NOTICE OF DECISION

Class 3 Design Review / Class 3 Site Plan Review / Class 2 Adjustment / Class 2 Driveway Approach Permit Case No. DR-SPR-ADJ-DAP17-06

SUMMARY: Proposed development of an 8-unit apartment complex, with an Adjustment request to reduce the required perimeter setback to the north, to reduce the vehicle use area setback adjacent to a building and to reduce the building setback adjacent to a street.

CASE NO: DR-SPR-ADJ-DAP17-06 – FACTS AND FINDINGS

3760 HAWTHORNE DR. PROPOSED SITE PLAN

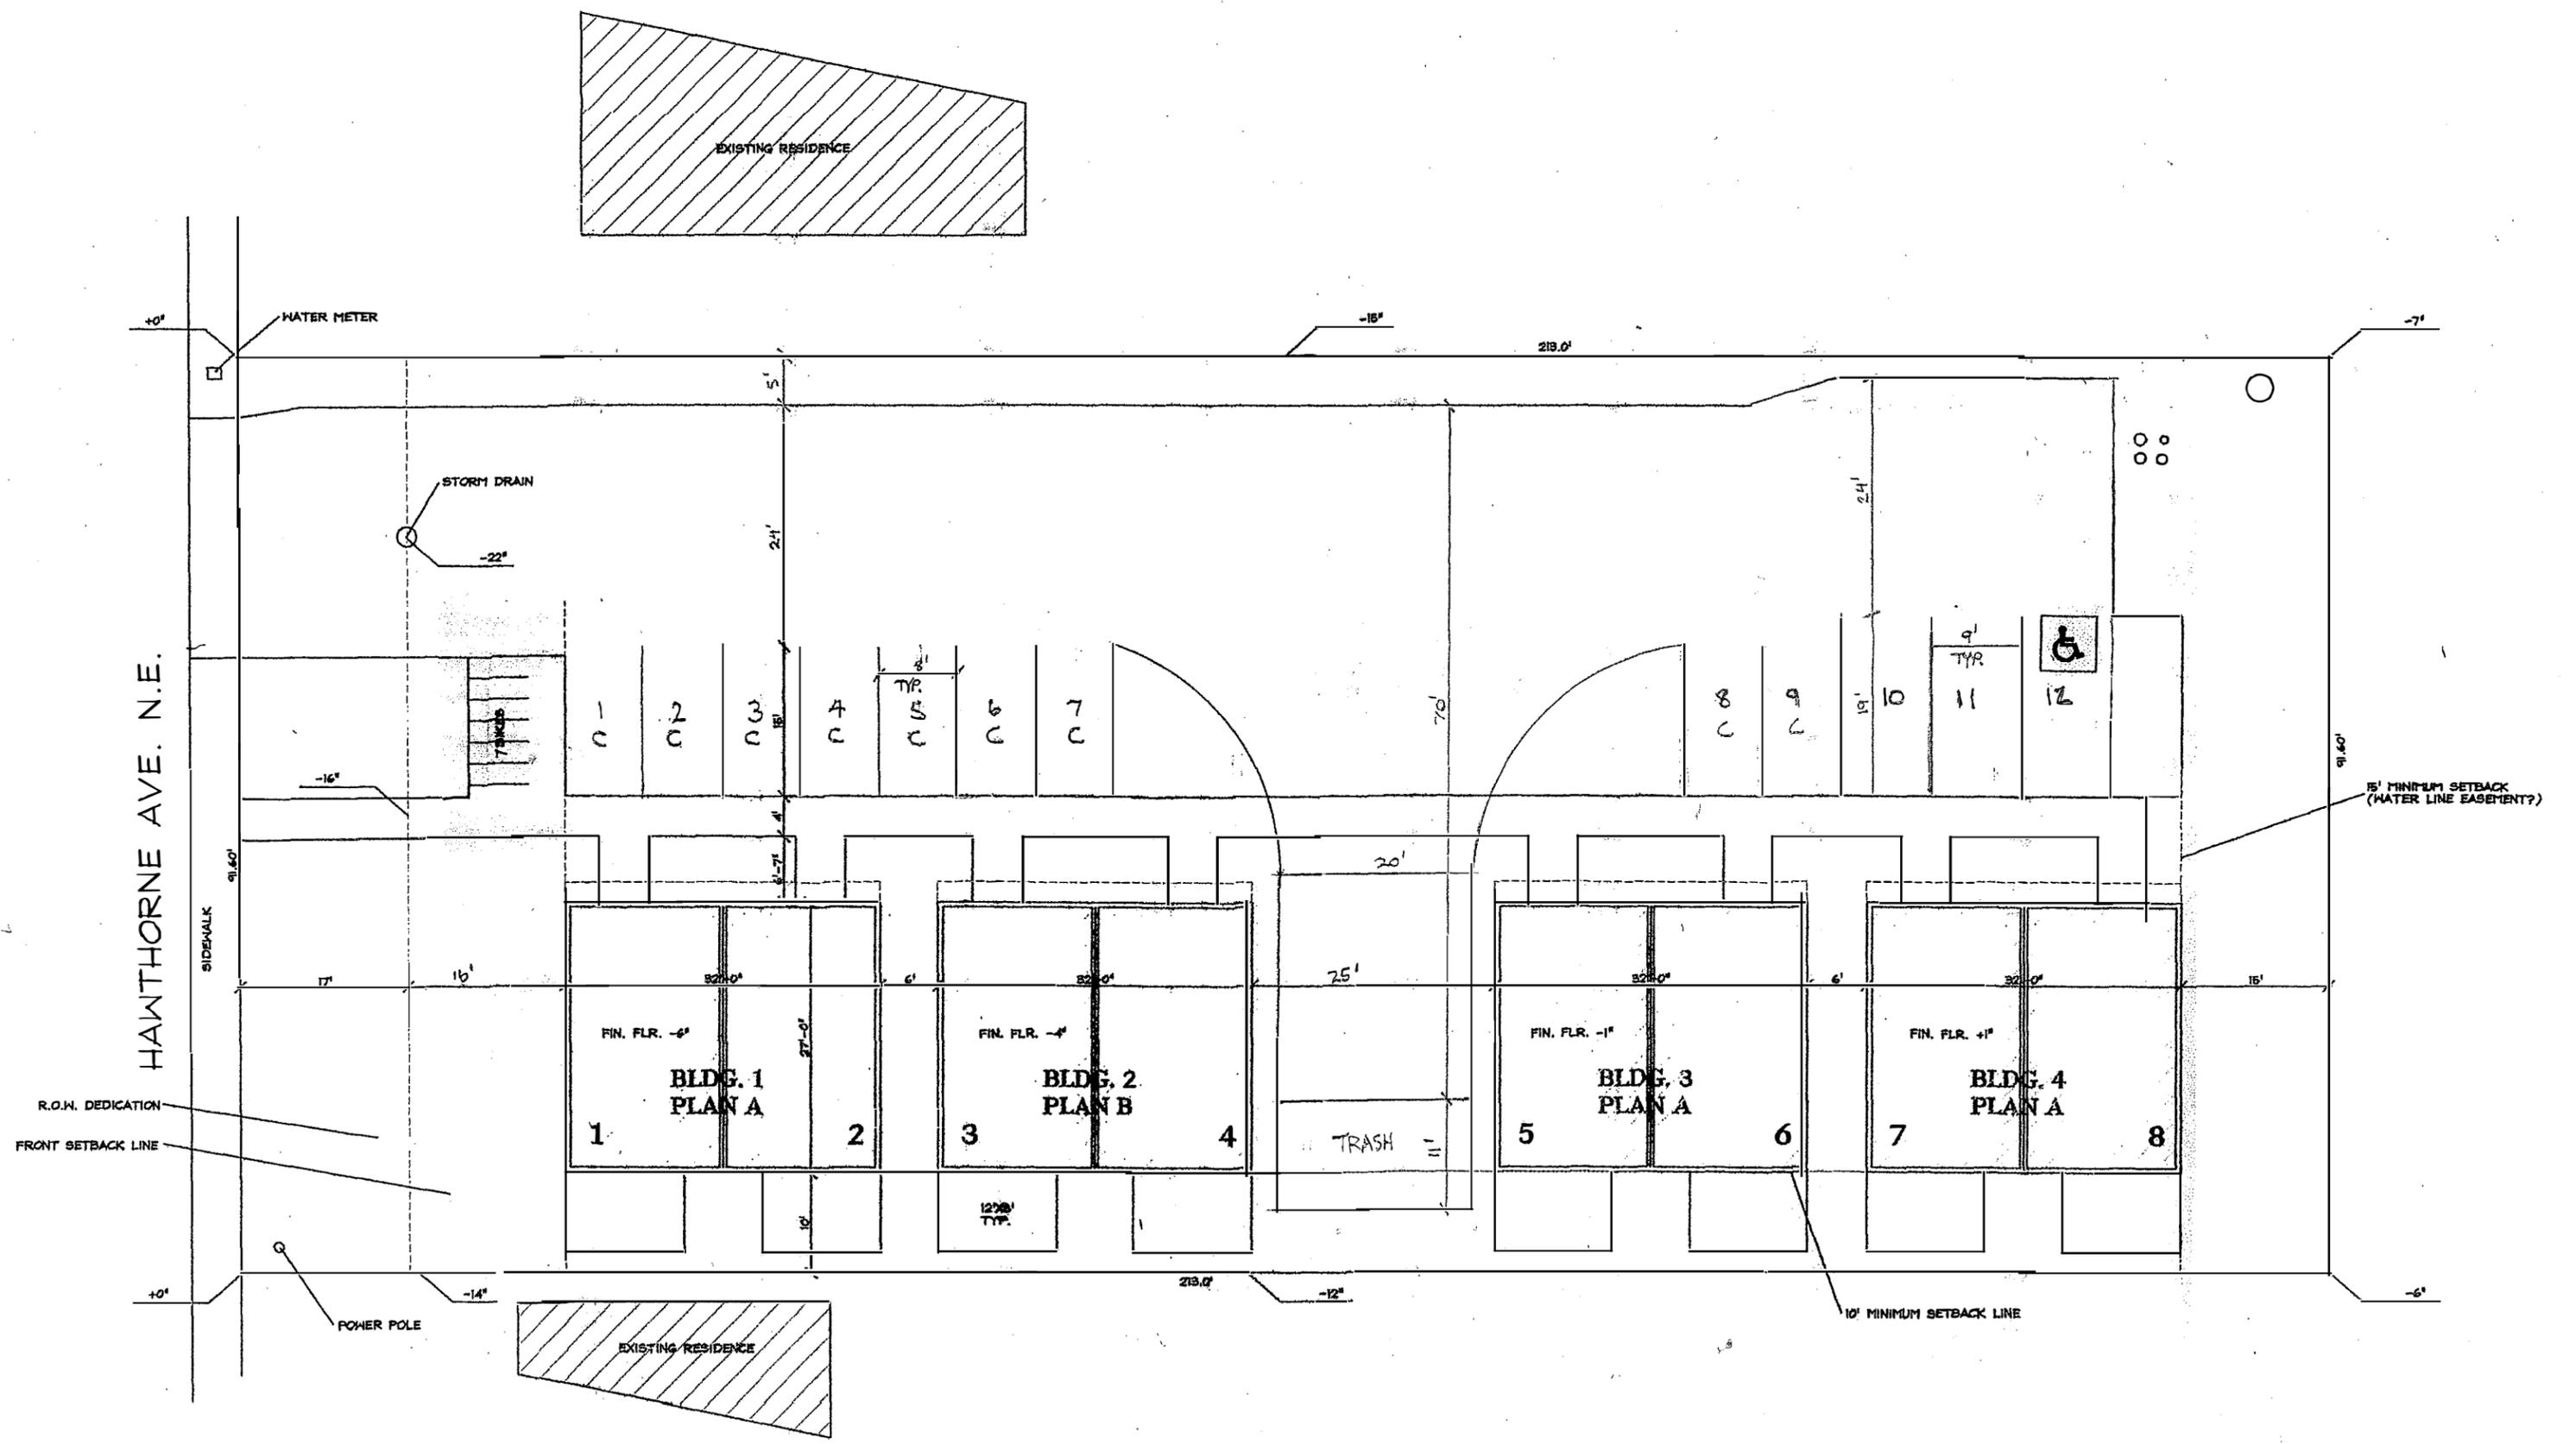
Finding: A marked crosswalk is indicated on the proposed site plan where a pedestrian pathway crosses the vehicle turnaround and trash enclosure service area.

Finding: Abutting property to the north and south is zoned multi-family residential. The proposed driveway on Hawthorne Avenue NE is located near the northern property line. With the configuration of the site plan, shared driveway access is not possible with the abutting property to the south, however, shared driveway access with the property to the north may be possible.

Finding: The proposed site plan indicates that each of the proposed buildings is placed at the 10 foot setback line. A minimum 6 foot tall fence is included along the southern boundary meeting the Type C landscaping requirement.

Finding: The proposed site plan indicates that the off-street parking area is approximately 5,472 square feet in size. A minimum of 274 square feet of interior parking lot landscaping is required ($5,472 \times 0.05 = 273.6$). The site plan indicates that approximately 314 square feet (5.7 percent) of interior parking lot landscaping is provided in the parking area.

The proposed parking area has more than 6 spaces and is required to be screened from abutting residentially zoned property by a minimum 6-foot-tall sight-obscuring fence, wall, or hedge. The proposed site plan indicates a minimum 6-foot-tall sight obscuring fence will be provided screening the proposed parking area from abutting residential uses.

Finding: The proposed development is for an 8-unit apartment complex, which requires a minimum of 4 bicycle parking spaces. The proposed site plan indicates 7 bicycle parking spaces will be provided, near the driveway entrance for the development site.

- Condition 5:** A minimum of 14 plant units shall be provided between the vehicle turnaround area and proposed buildings 2 and 3.
- Condition 6:** A minimum of 92 plant units shall be provided in the setback area between proposed building 1 and Hawthorne Avenue NE.

- Condition 7:** The adjusted perimeter and interior setbacks, as approved in this zoning adjustment, shall only apply to the specific development proposal shown in the attached site plan. Any future development, beyond what is shown in the attached site plan, shall conform to the setback requirements for the development site, unless adjusted through a future land use action.

Condition 5: A minimum of 14 plant units shall be provided between the vehicle turnaround area and proposed buildings 2 and 3.

Condition 7: The adjusted perimeter and interior setbacks, as approved in this zoning adjustment, shall only apply to the specific development proposal shown in the attached site plan. Any future development, beyond what is shown in the attached site plan, shall conform to the setback requirements for the development site, unless adjusted through a future land use action.
